Access Compliance Report

Public Rights-of-Way

(Curb Ramps)

Intersection ID: 7076	Main Street: ACORN_OAKS_RD	Cross Street: BEGONIA_DR	Location:	N
ADA ID: A5873D095E04	Ramp Type: Perp	Initial Pass/Fail: Fail	Overall Compliance: No	Severity Score: 8.75
Codes/Mitigation Info/Possible Solution		Field Measurements/Component Compliance

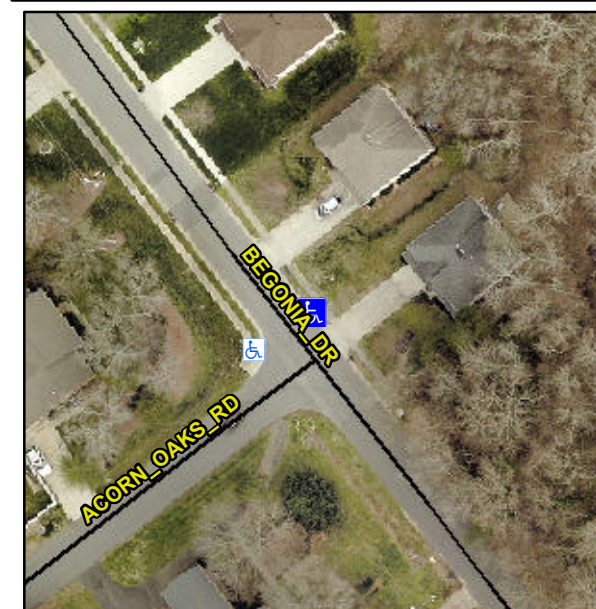
Not Found, R304.5.1

Compliance	Description	Data	Compliance	Description	Data
N/A	Ramp Length (in)	47.0	Yes	Ramp Slope (%)	6.1
No	Ramp Width (in)	47.5	Yes	Ramp XSlope (%)	1.7
N/A	Flare Type LT	N/A	N/A	Flare Type RT	N/A
N/A	Flare Slope LT (%)	N/A	N/A	Flare Slope RT (%)	N/A
N/A	Flare Traversable LT?	N/A	N/A	Flare Traversable RT?	N/A
N/A	Landing Length (in)	N/A	N/A	DWS Provided?	N/A
N/A	Landing Width (in)	N/A	N/A	DWS Contrast?	N/A
N/A	Landing Slope (%)	N/A	N/A	DWS Length (in)	N/A
N/A	Landing X Slope (%)	N/A	N/A	DWS Full Width?	N/A
N/A	Landing Curb? (Y/N)	N/A	N/A	DWS Offset (in)	N/A
N/A	Shared Landing?	N/A			
N/A	Gutter Ponding?	N/A	N/A	Gutter Slope (%)	N/A
N/A	Gutter Lip Ht (in)	N/A	N/A	Gutter X Slope (%)	N/A
N/A	Painted X Walk1?	No	N/A	Painted X Walk2?	N/A
	X Walk 1 Direction	To SW		X Walk 2 Direction	N/A
N/A	X Walk 1 Width (in)	N/A	N/A	X Walk 2 Width (in)	N/A
	X Walk 1 Slope (%)	3.5		X Walk 2 Slope (%)	N/A
	X Walk 1 X Slope (%)	2.1		X Walk 2 X Slope (%)	N/A

Remove & Replace Entire Ramp.
